# London Southend Airport Consultation Feedback Report

Introduction of New Approach Procedures

Issue 1.1

Figure 1 - Image illustrating London Southend CAS (incl. Danger Areas)

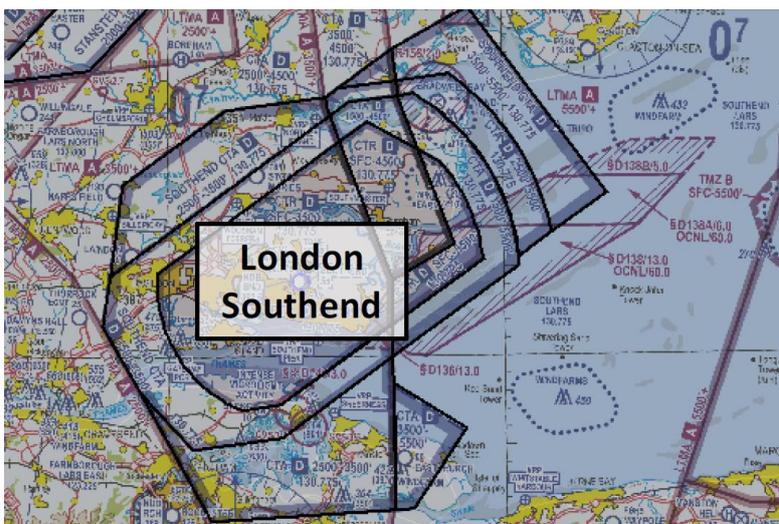
8. Will the new procedures fall within any danger areas or interact with the D138 military complex? (See Figure 1)
  - a. The South IAF for Runway 23 falls within the D138A danger area but has been designed to ensure that it does not interact with the D138 / D138B / D138C Danger Areas. If D138A is in use, the UPUDU route will not be available.

Figure 17 - RNAV design from the south to Runway 05

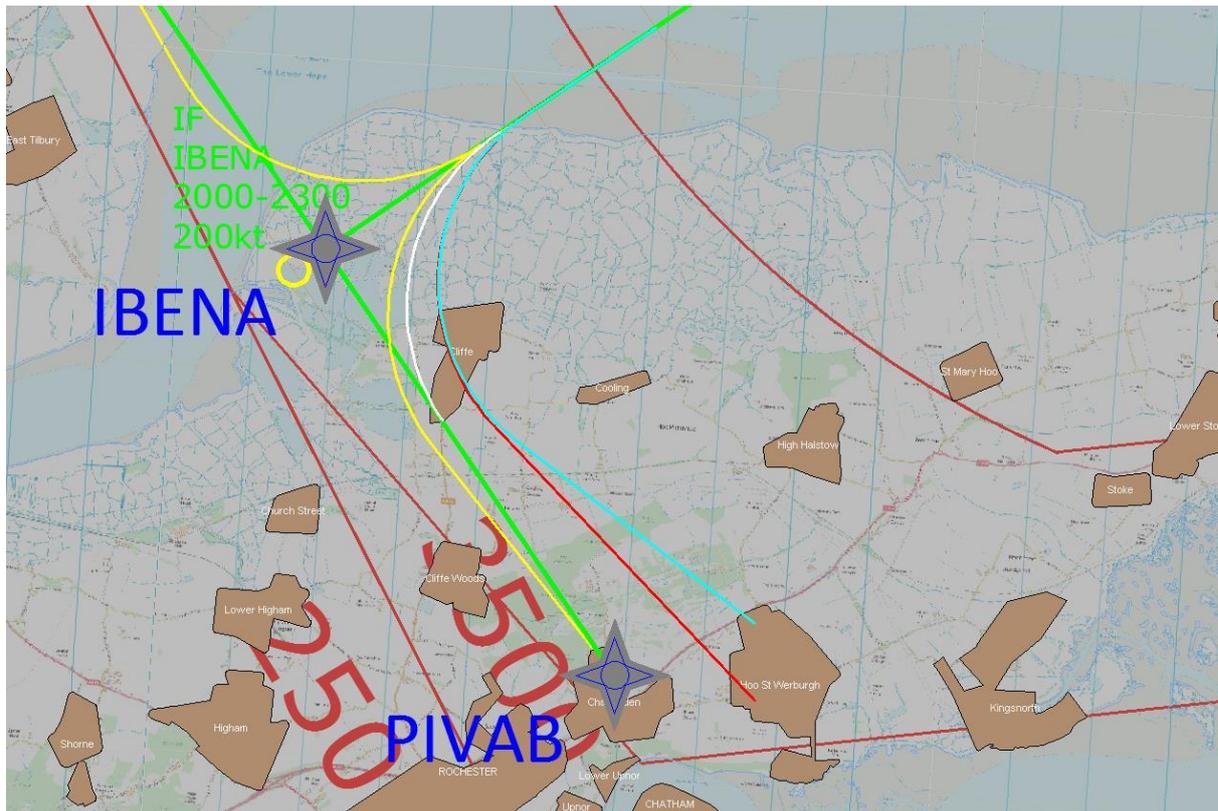
Options were considered to try to reduce the impact of the proposed routes on Cliffe & Cliffe Woods, see Figure 17. The route options available are constrained by the London Terminal Manoeuvring Area (LTMA), the area in which aircraft inbound to London's other major airports fly, which surrounds LSA's airspace.

3. see Figure 17 below illustrating this, where:
    - The Western **red** line illustrates the LTMA;
    - The **green** line shows the current procedure, with **white** lines showing an expected aircraft trajectory;

- The **yellow** line & circle show moving IBENA to the West which lead to airspace coordination issues with London City Airport traffic and the complexity of the LTMA;

- The **cyan** line shows adjusting the angle of the Southern approach to the East routing towards the new Western IBENA (**yellow** circle) overflying Hoo St Werburgh.

- Moving IBENA East along the extended runway centreline reduces the distance between IBENA and the Final Approach Fix (FAF) below that permitted by ICAO design criteria.

Figure 19 - Image showing new procedures around Hockley

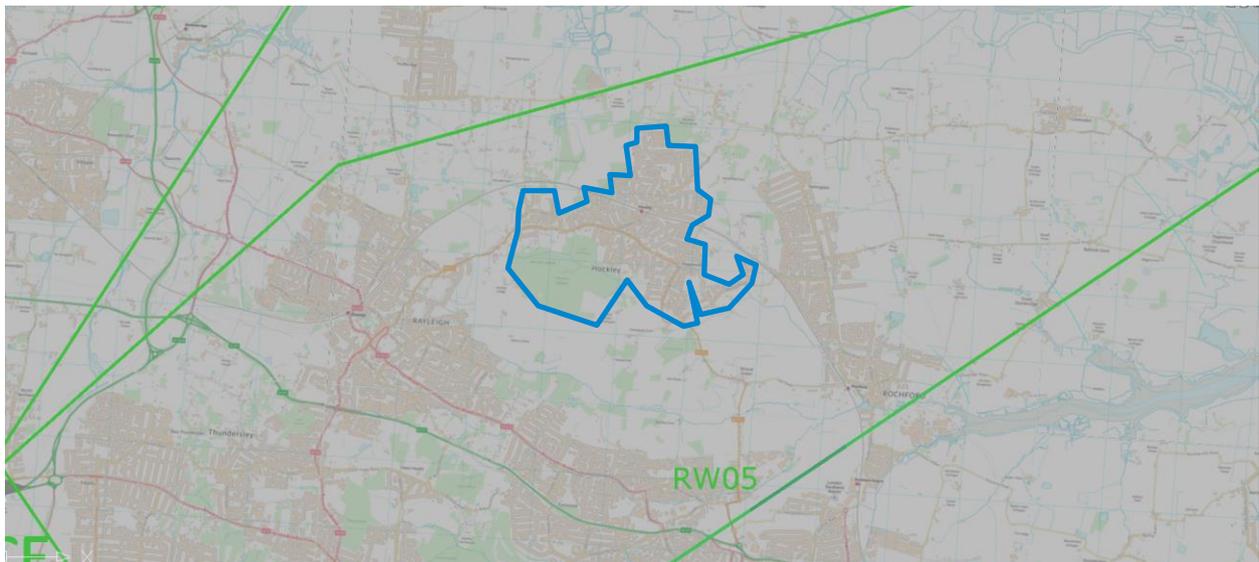
1. The implementation of these new procedures will cause an increase in noise and pollution around Hockley.
  - a. All routes that have been designed do not directly overfly Hockley as shown in Figure 19.
